# CITY OF SAN ANTONIO

Re: Menn Tract

POADP # 718

The City Staff Development Review Committee has reviewed : Menn Tract Master Development Plan (M.D.P.) formerly (POADP) # 718. Please find enclosed a signed copy for your files. Your plan was accepted, however please note the following:

**PRELIMINARY OVERALL AREA  
DEVELOPMENT PLAN**

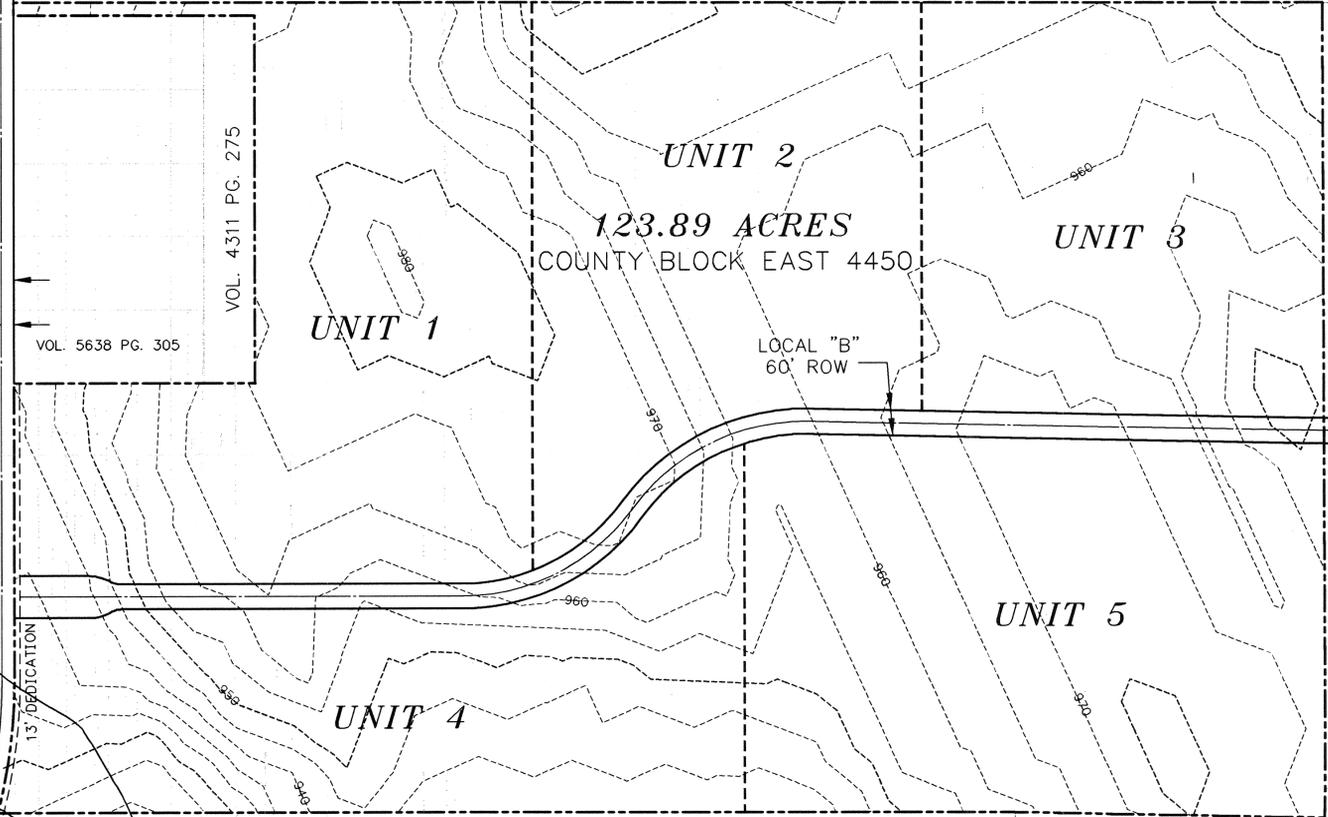
- In consideration of public safety and convenience, excessive grades by reason of topography should be avoided in street layouts and arrangements.
- Access and R.O.W. issues along state facilities will need to be resolved with the Texas Department of Transportation (TXDOT). For information about these requirements you can contact TXDOT at 615-5814.
- This development will need to comply with tree preservation ordinance #85262. For information about these requirements you can contact Building Inspections at 207-7102.
- It will be expected that you will plat all of the property depicted in your M.D.P., to include: floodplains, drainage areas and open space.
- I would encourage you to work closely with the school district, so that they can plan accordingly.
